TfNSW Reference: SYD24-00666  
Planning Proposal PP-2022-731

**RE: PLANNING PROPOSAL - 488-492 Old South Head Road and 30 Albemarle Avenue, Rose Bay**

**Subject: Exhibition of Planning Proposal – 488-492 Old South Head Road and 30 Albemarle Avenue, Rose Bay (PP-2022-731)**

**Subject: RTS – 488-492 Old South Head Rd and 30 Albemarle Ave, Rose Bay (PP-2022-731)**

Figure 2: Extract of Development Flood Effects Flood Depth Difference PMF Flood Event (Source: Northrop)

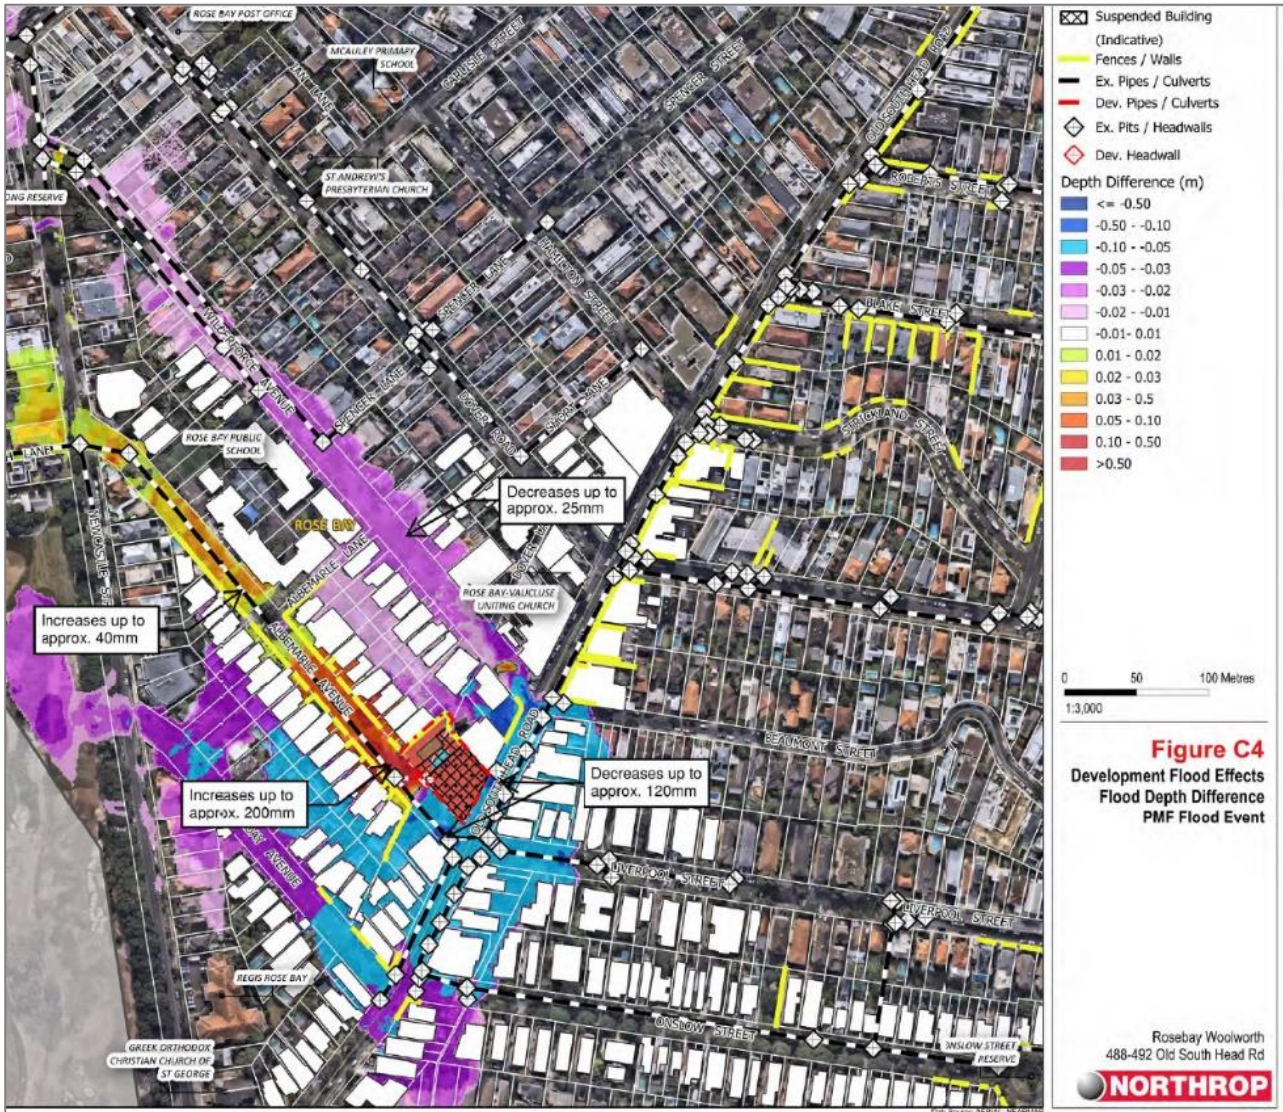
## Excessive flood afflux in the developed scenario

The planning proposal raises concerns as it may result in excessive flood impacts on public roads, which increases in flood depth reaching up to 0.2 m in some areas of Albemarle Avenue (as shown in Figure 2). This depth compounds the existing high hazard classification (H5) of public roads (within the PMF zone), further intensifying flood risk and safety concerns as the development can cause significant flood impacts to other properties and public road infrastructure. The FIRA should be updated to address any adverse impacts on the emergency management arrangement of existing community including managing risks that may be faced by the itinerant population.

Figure 3: Extract of Flood Effects Flood Hazard (ARR 2019) PMF Flood Event (Source: Northrop)

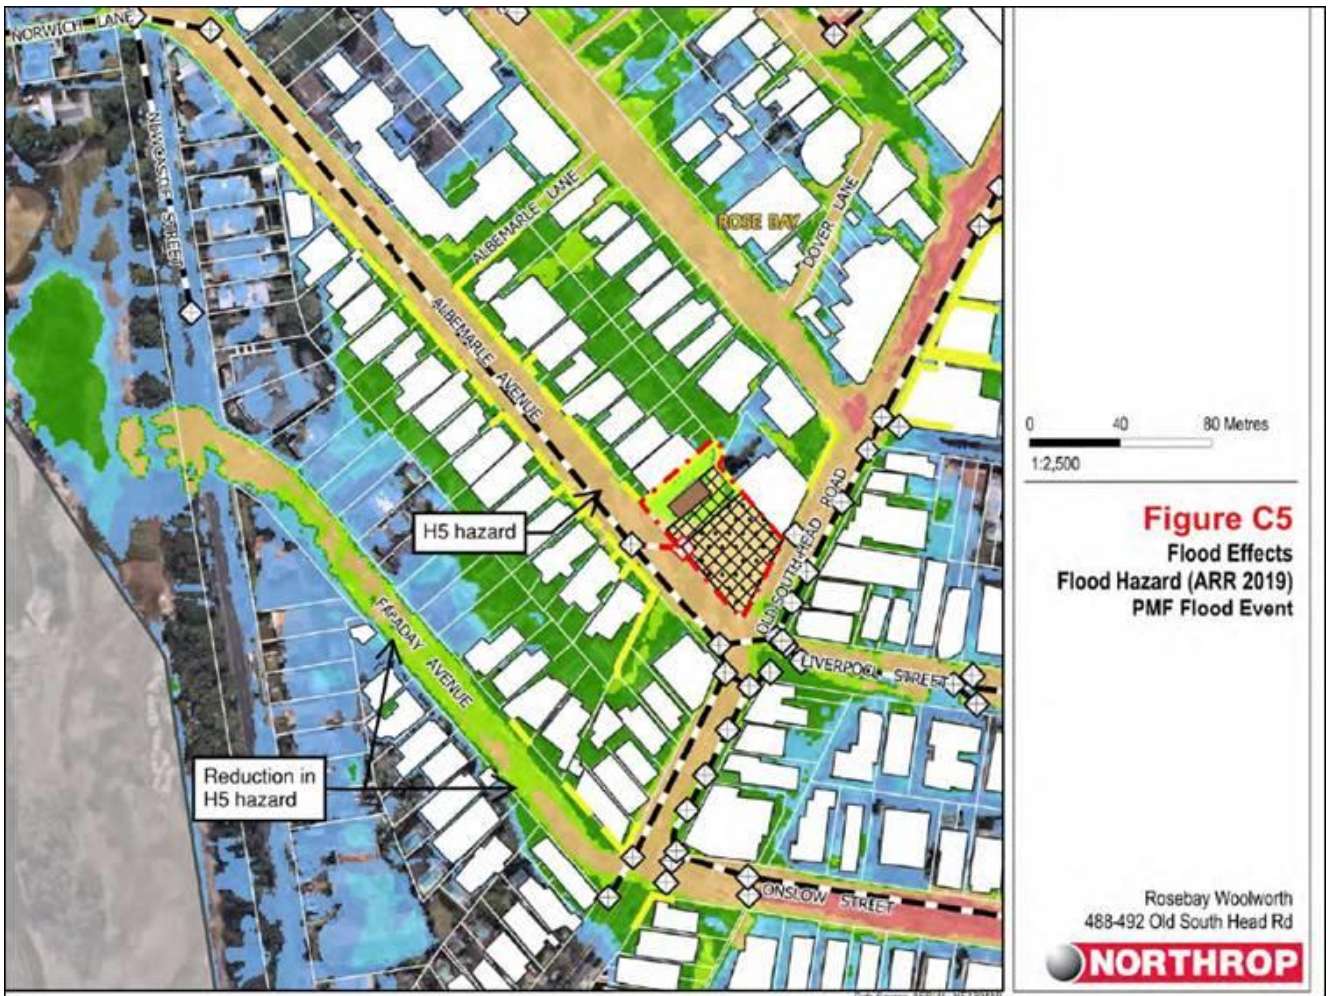
The site is surrounded by H5 floodwaters in the PMF event, creating substantial challenges for emergency management and evacuation due to the high hazard level and the risk of isolation (as shown in Figure 3). This classification signals extreme flood risk, which complicates evacuation routes and heightens danger for both residents and emergency responders.

BCS recommends that the proponent demonstrates that safe, elevated access can be maintained across the full range of flood events. BCS request further information about the duration of isolation for the full range of events. BCS do not support a 'Shelter in Place' strategy for new developments in high hazard flood prone land. BCS consider it likely that the development would require additional government expenditure to enhance emergency management services, flood mitigation

infrastructure, and road safety measures to manage increased flood risks. No evidence of consultation with the NSW SES has been provided in the updated FIRA. BCS recommend that the NSW SES should be consulted on all matters related to emergency management constraints to ensure alignment with emergency response requirements resulting from the intensification of the site.
